LINCOLN PARK PLANNING COMMISSION

Site Plan Review

Applicant	Reefer Peterbilt
Project	Retail (Truck Parts & Supplies)
Address	3535 Fort Street, Lincoln Park, MI 48146
Date	March 9, 2022
Request	Site Plan Review

SITE PLAN LOCATION MAP

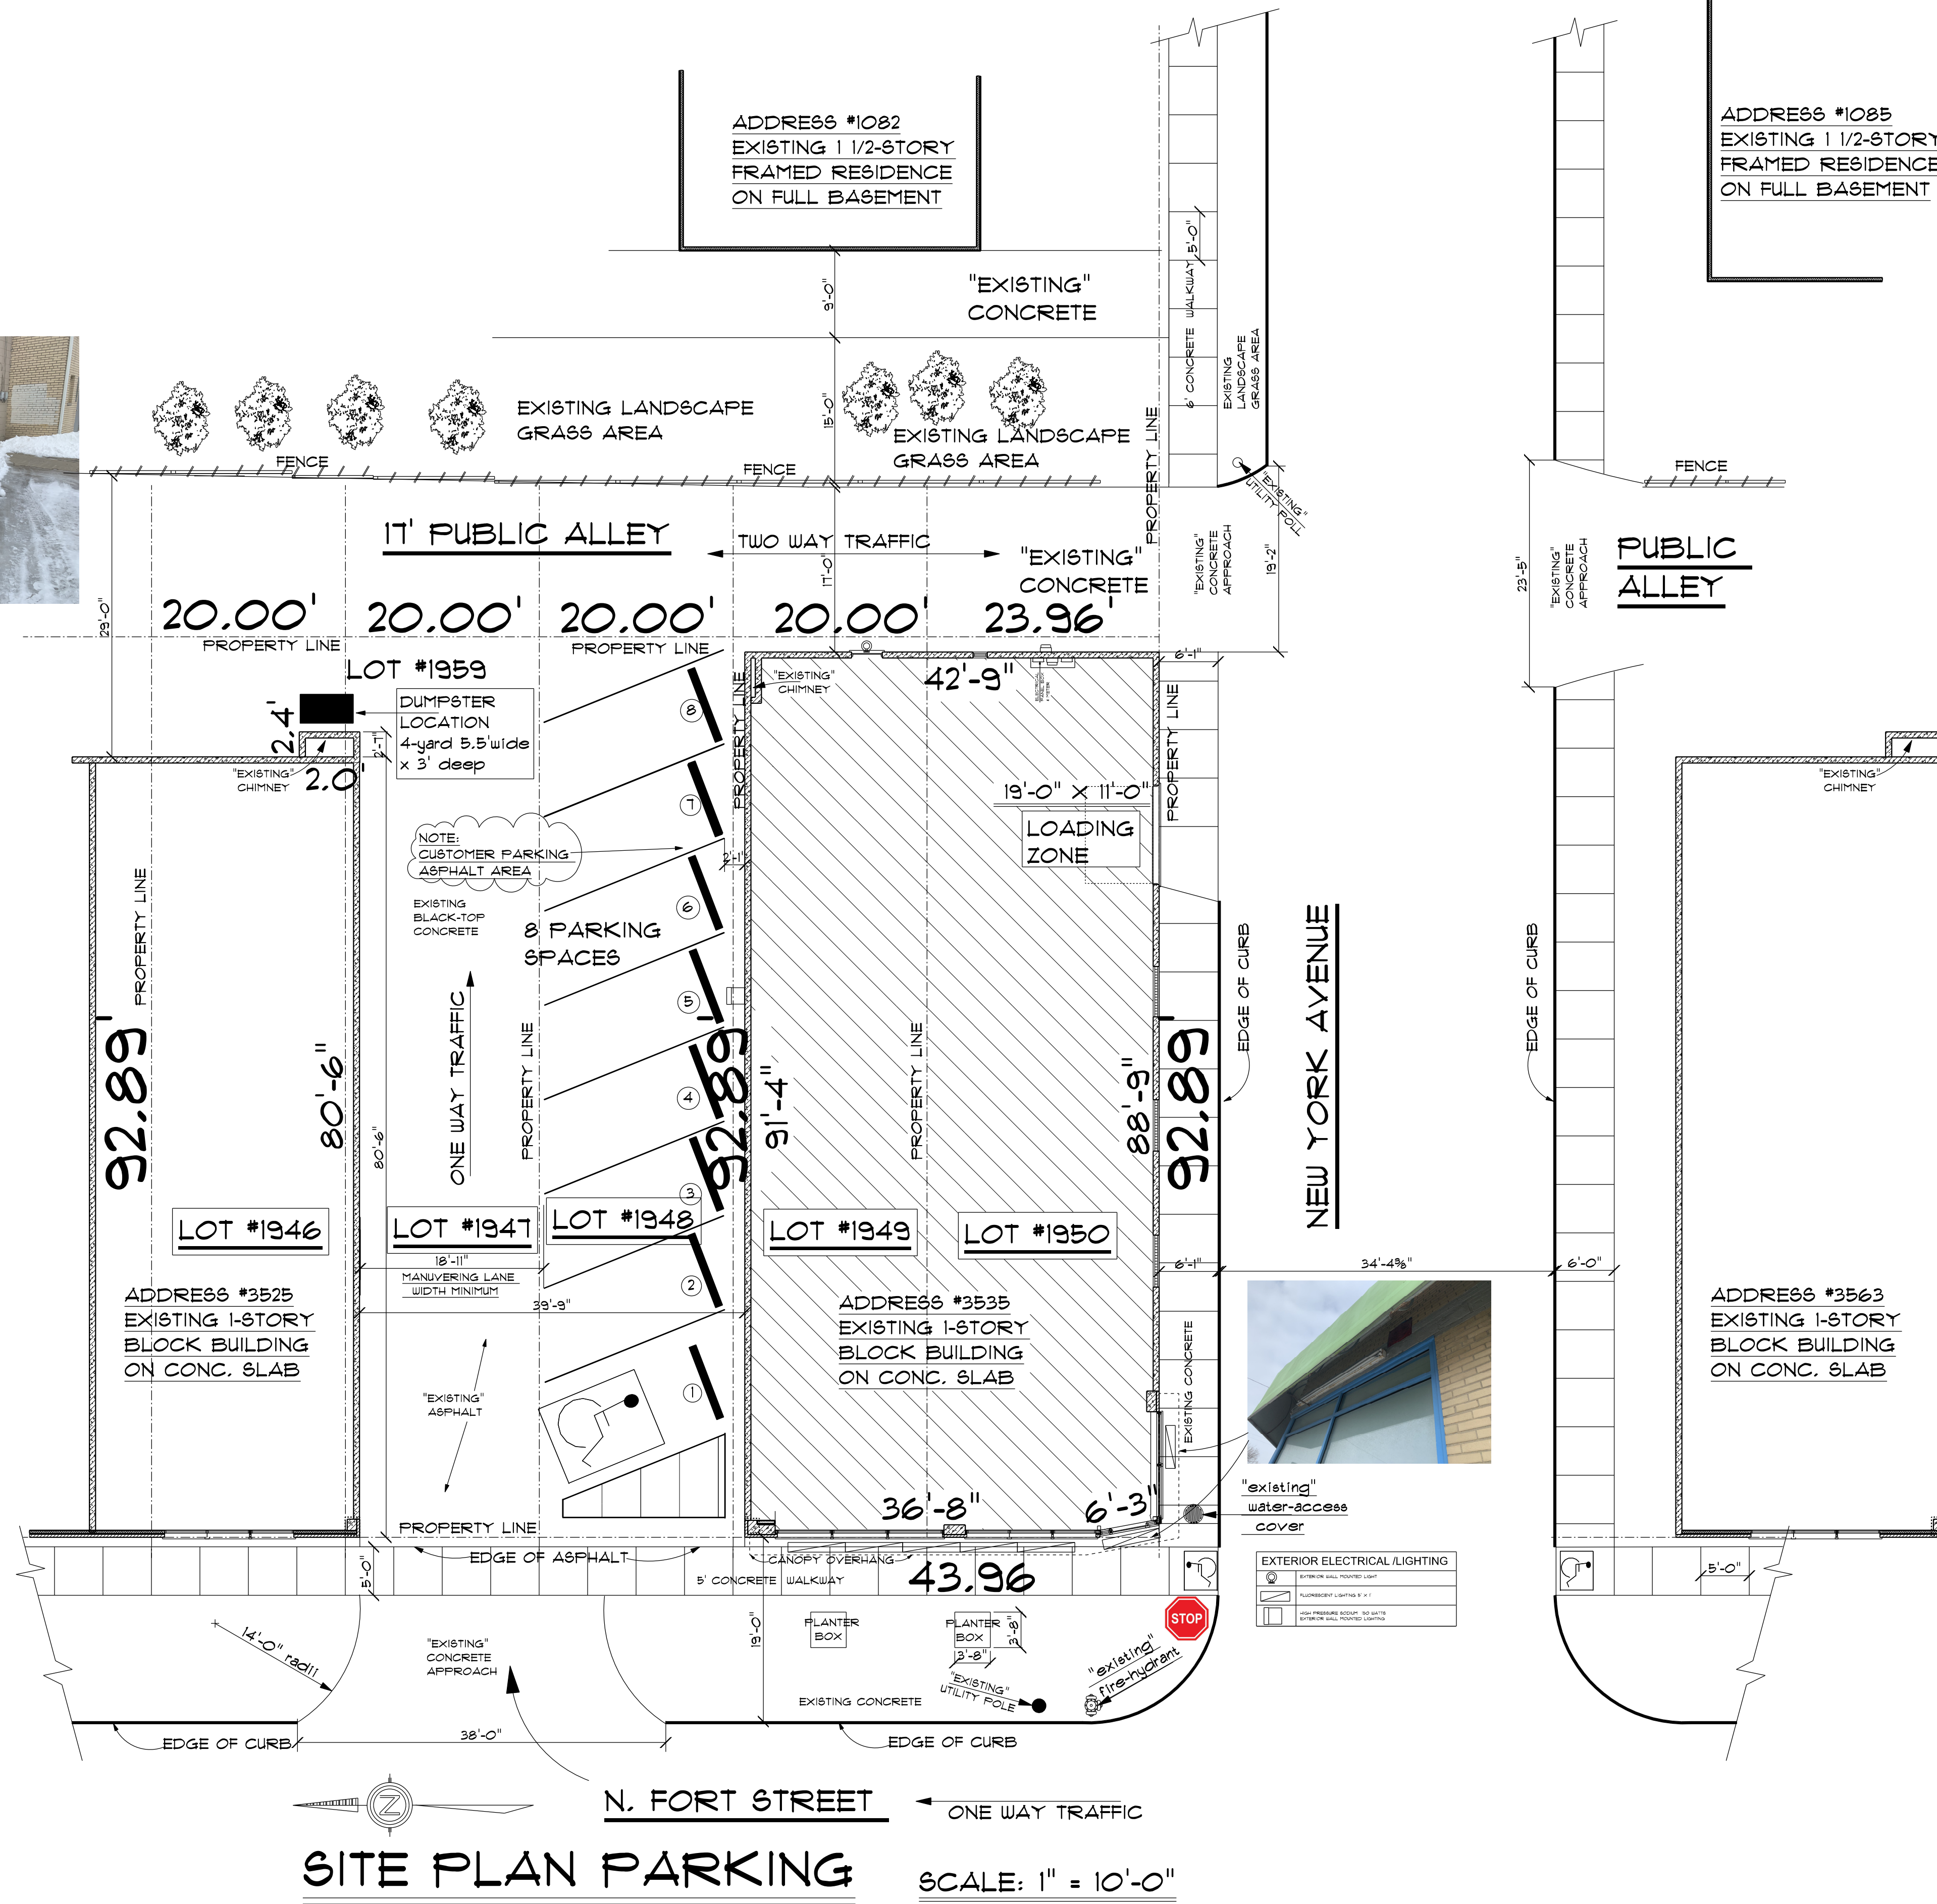
The parking lot is a shared lot between the subject property and the building to the north with the same owner. The proposed number of the parking spaces does not comply with the parking requirements for the proposed use, and the small lot size prevents the applicant from providing the required 15 parking spaces. However, there is also on-street parking along New York Avenue, and the existing parking lot provides over half of the required spaces. It is the Planning Commission’s responsibility to determine whether the proposed parking plan offers adequate provision for the intended use while preserving the public health, safety, and welfare.

- A parking waiver is requested from the Planning Commission from the required 15 parking spaces. Factors for consideration are the size of the site and available on-street parking on New York Ave.
- Applicant shall provide a letter of agreement for the adjacent shared parking lot to the north.

- Applicant shall provide a letter of agreement for the adjacent shared parking lot to the north.

PROPOSED BUILDING
FLOOR PLAN

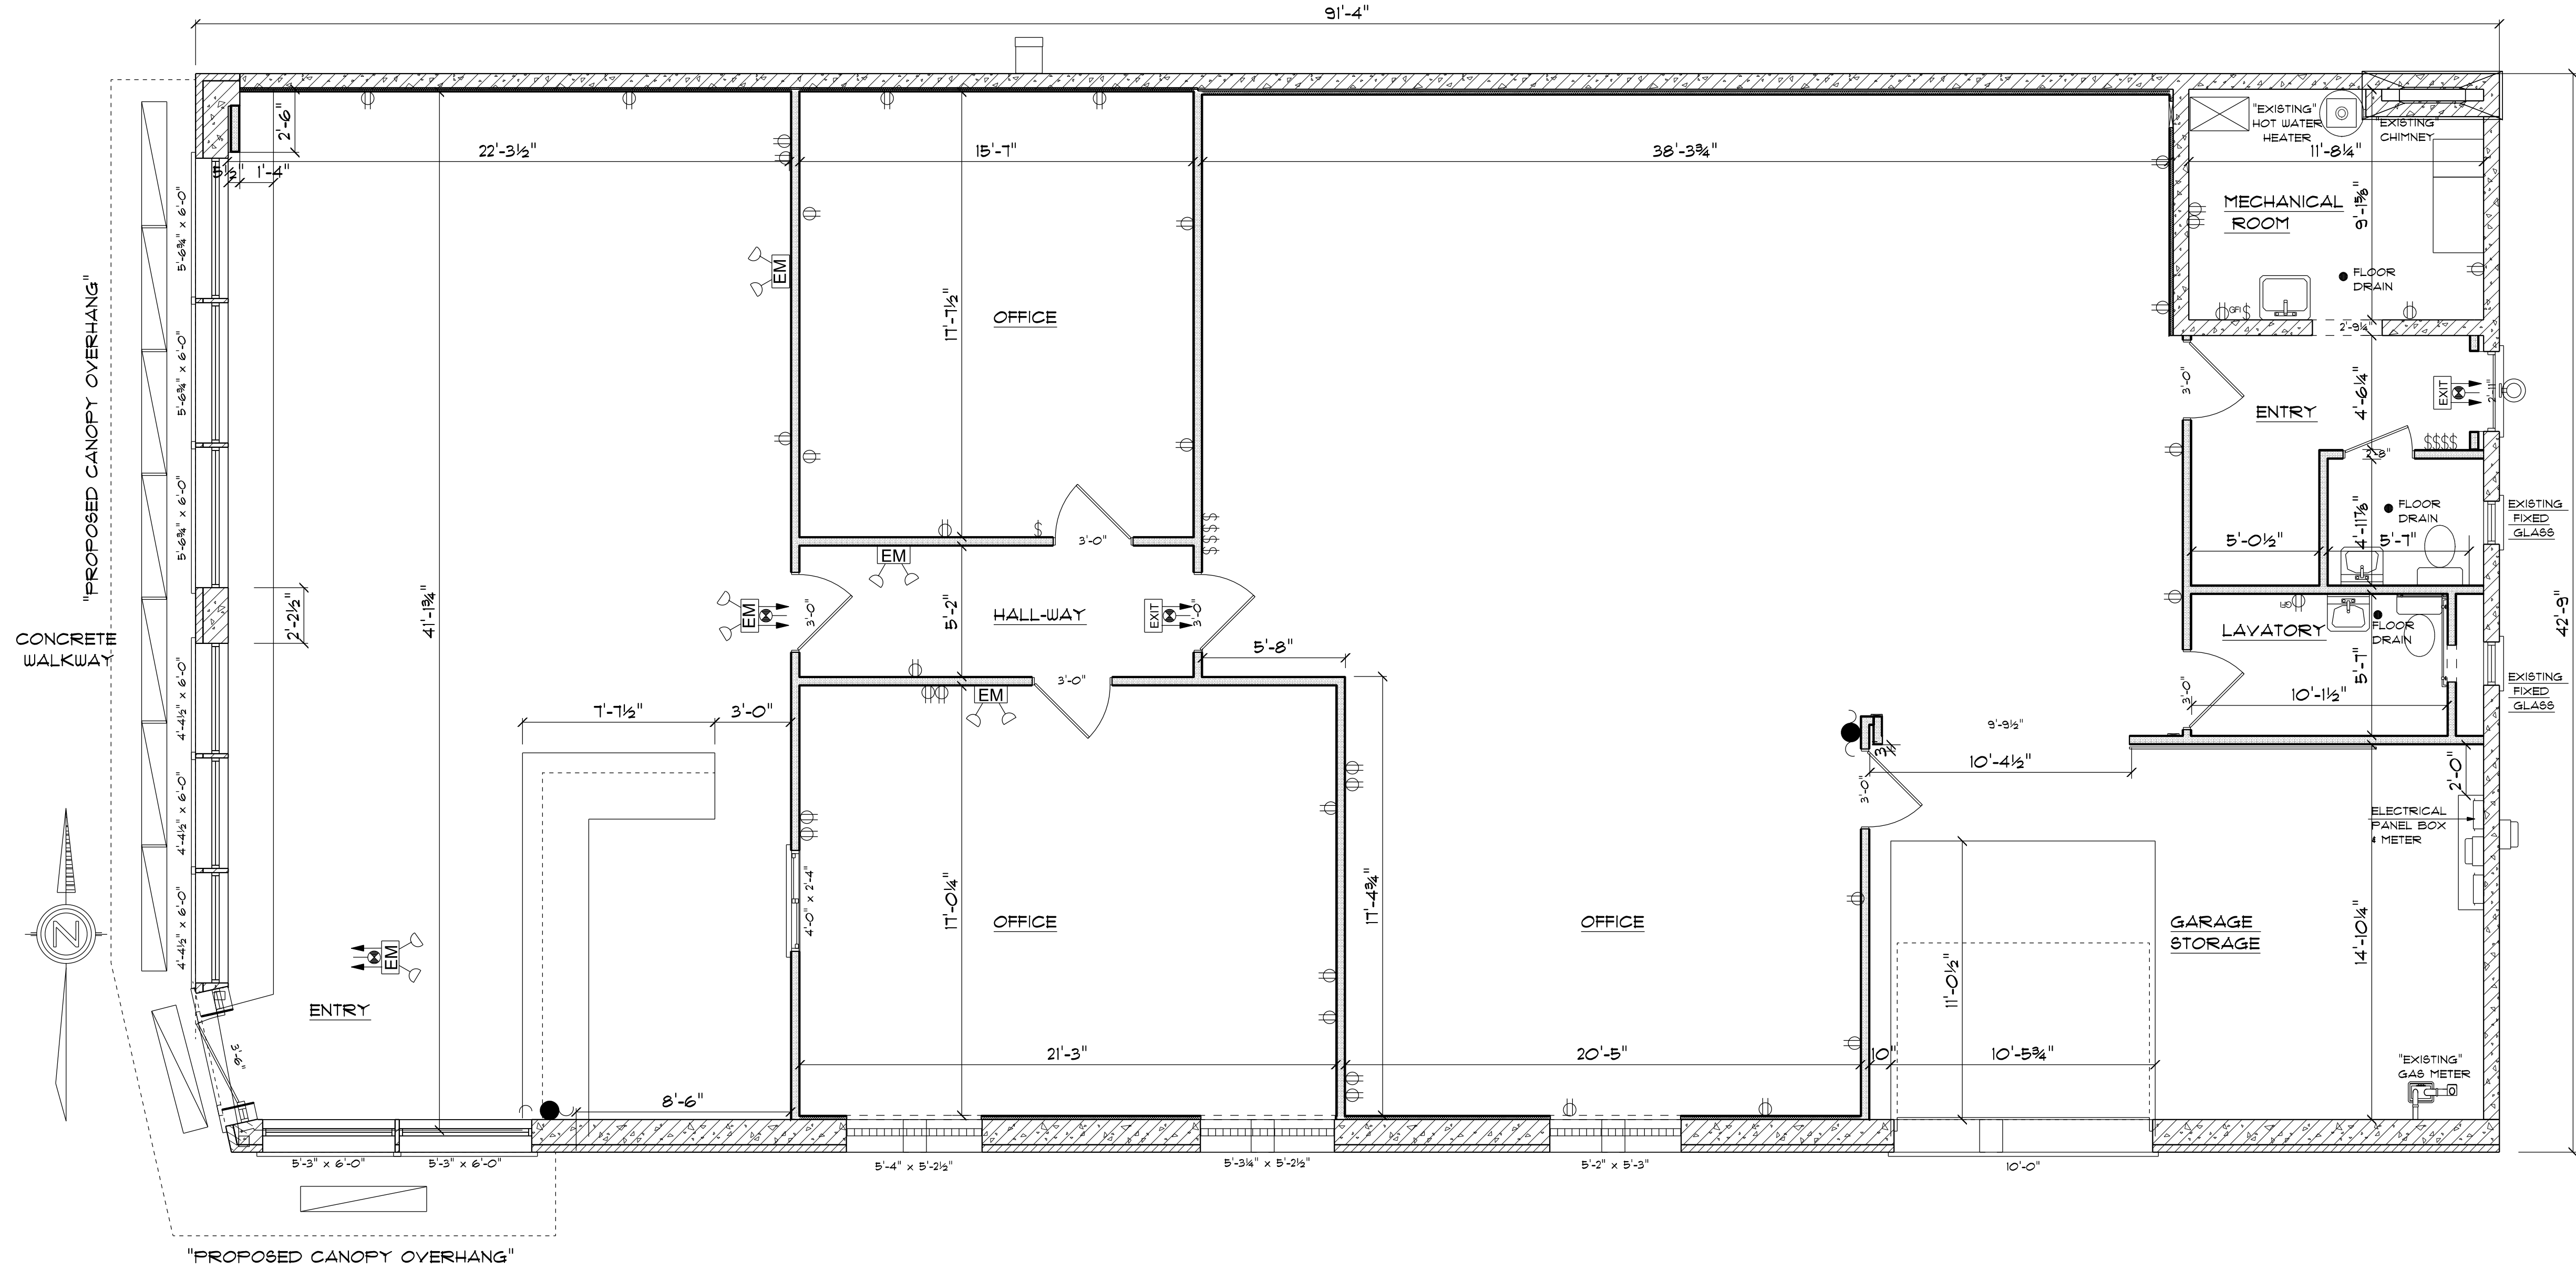
- Applicant shall provide the required loading and unloading space in accordance with §1290.09 of Lincoln Park Zoning Code.

**SHEET TITLE
PROP SITE PLAN
REZONE 2 PARCELS**

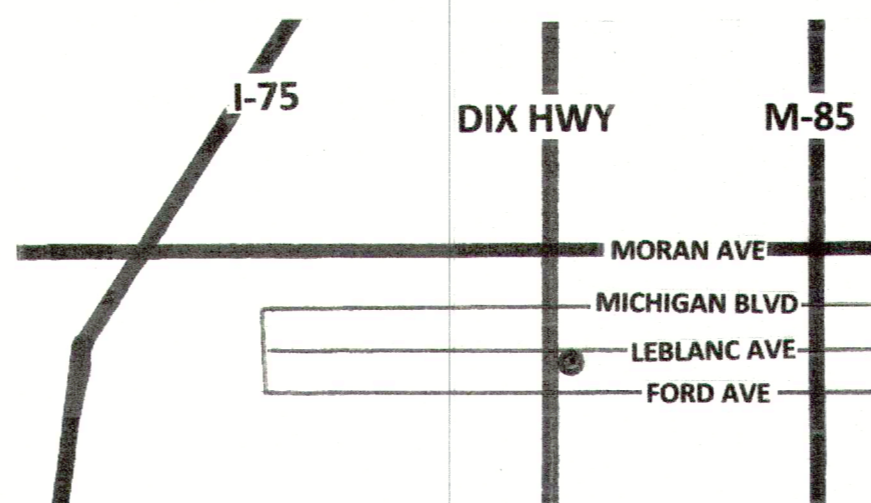
- Applicant shall provide dates on all site plan documents.
- Applicant shall combine the two lots on a the same deed to ensure that they remain a single site.

- Applicant shall provide drive radii on Dix Highway.*
